Recall Bulletin

F/CMVSS NONCOMPLIANCE RECALL

SUBJECT: Floor Console Armrest Latch

MODELS: 2016 Chevrolet Colorado
2016 GMC Canyon

3710733

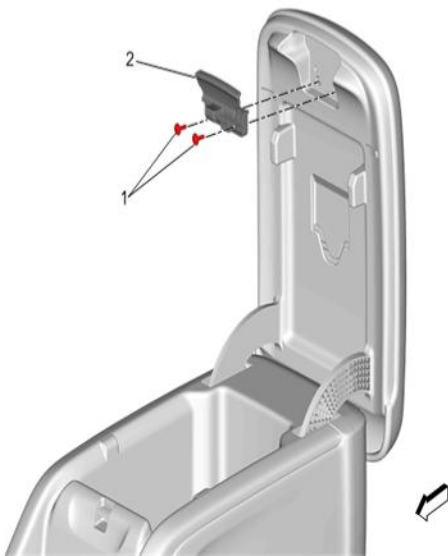
General Motors has decided that certain 2016 model year Chevrolet Colorado and GMC Canyon vehicles may have a console-compartment door latch assembly that does not comply with Federal Motor Vehicle Safety Standard (FMVSS) No. 201, "Occupant protection in interior impact." The supplier of these latch assemblies may have produced assemblies using the wrong latch spring, and that latch spring could fail to hold the console-compartment door closed during the test procedures specified in Section 5.3 of FMVSS 201. The console-compartment door may not remain closed in a crash, increasing the risk of occupant injury.

1. Replace the front floor console compartment door latch (2). Refer to *Front Floor Console Compartment Door Latch Replacement* in SI.
